APPLICATION FOR PERMIT TO DRILL						1. WELL NAME and NUMBER State 11-34-3-3W								
2. TYPE OF WORK DRILL NEW WELL <input checked="" type="checkbox"/> REENTER P&A WELL <input type="checkbox"/> DEEPEN WELL <input type="checkbox"/>						3. FIELD OR WILDCAT WILDCAT

Newfield Production Company
State 11-34-3-3W
NE/SW Section 34, T3S, R3W
Duchesne County, UT

Application for Permit to Drill Statement of Basis

Permit To Drill

Casing Schematic

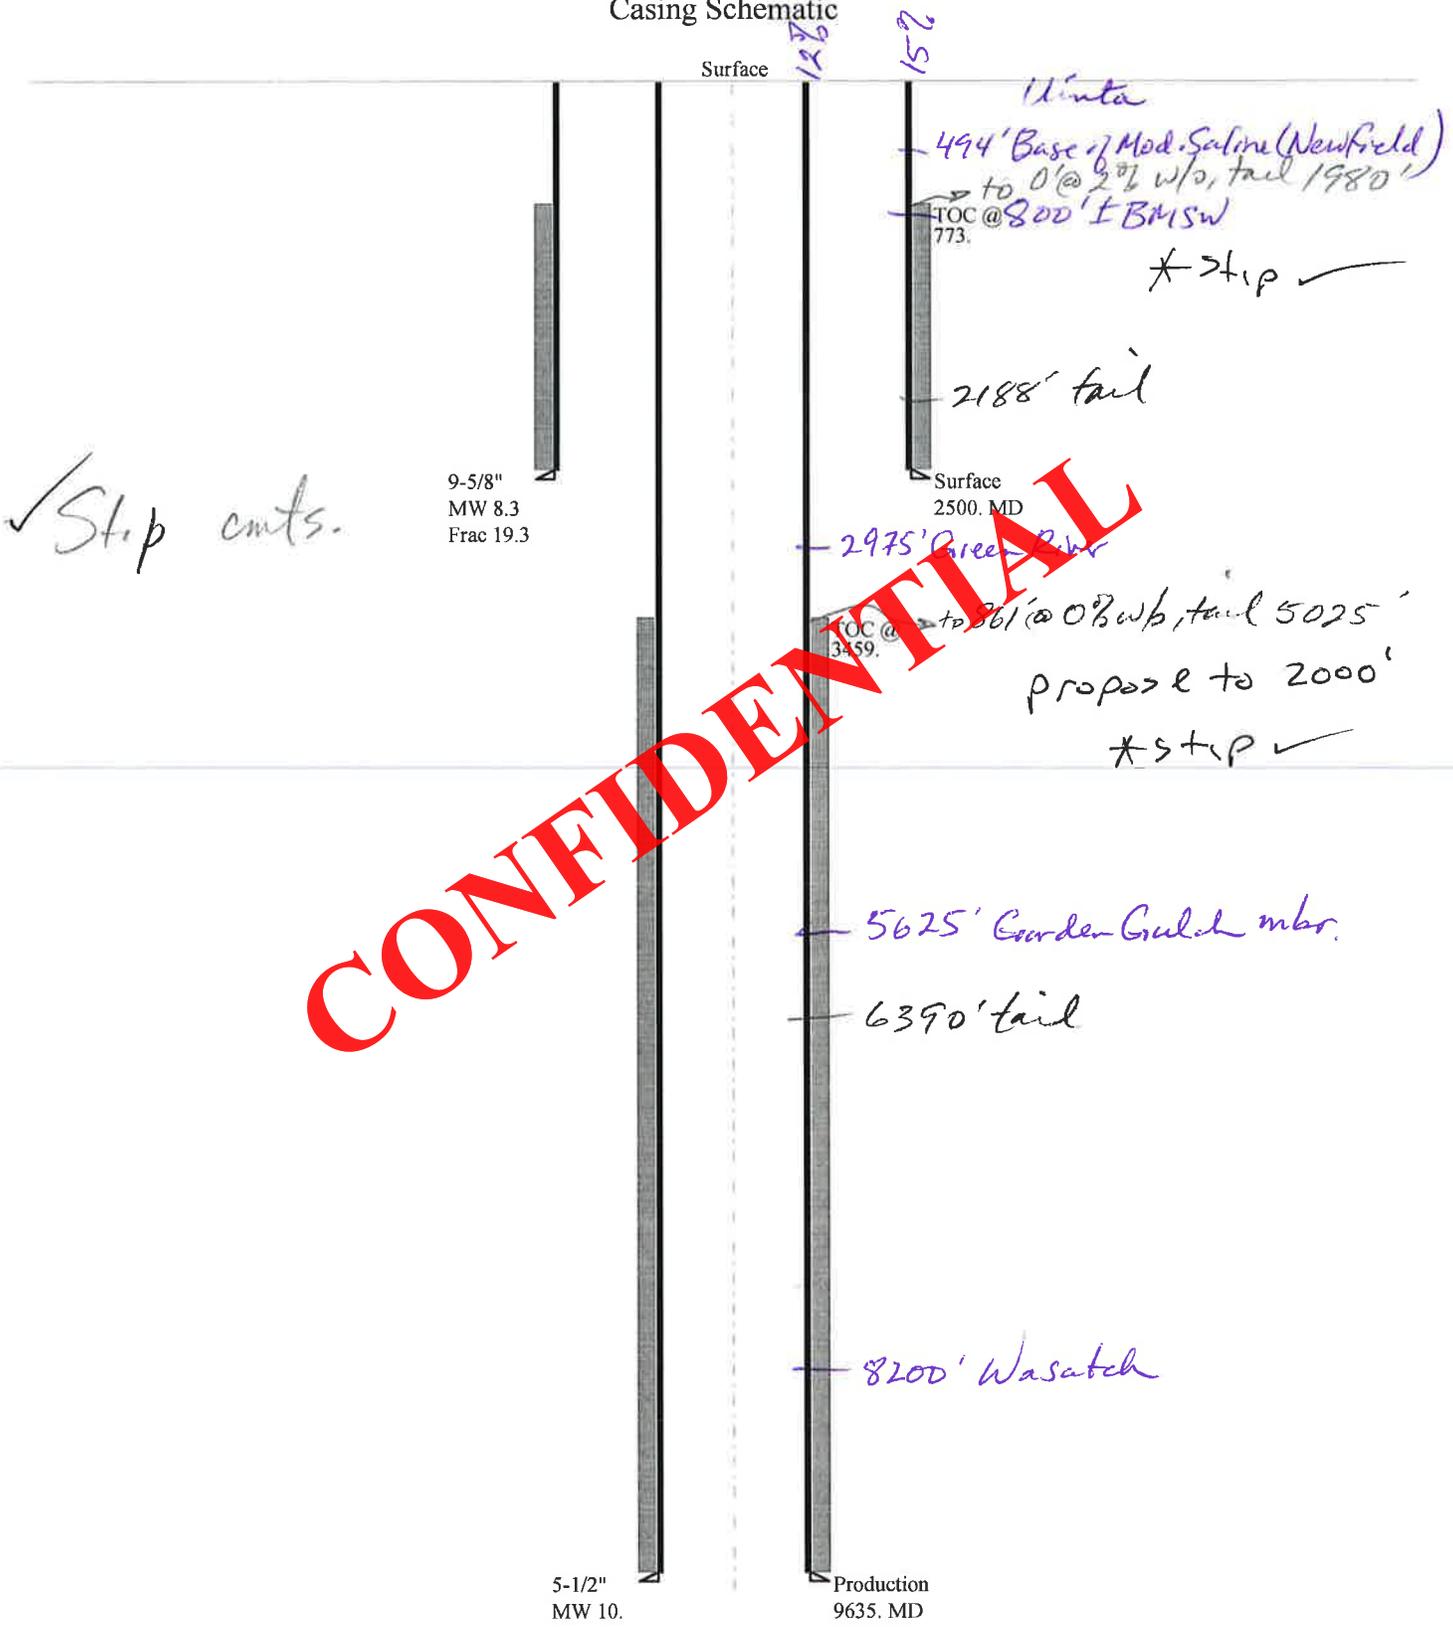
Collapse is based on a vertical depth of 2500 ft, a mud weight of 8.33 ppg. The casing is considered to be evacuated for collapse purposes. Collapse strength is based on the Westcott, Dunlop & Kemler method of biaxial correction for tension.

Burst strength is not adjusted for tension.

Collapse is based on a vertical depth of 9635 ft, a mud weight of 10 ppg. The casing is considered to be evacuated for collapse purposes. Collapse strength is based on the Westcott, Dunlop & Kemler method of biaxial correction for tension.

Burst strength is not adjusted for tension.
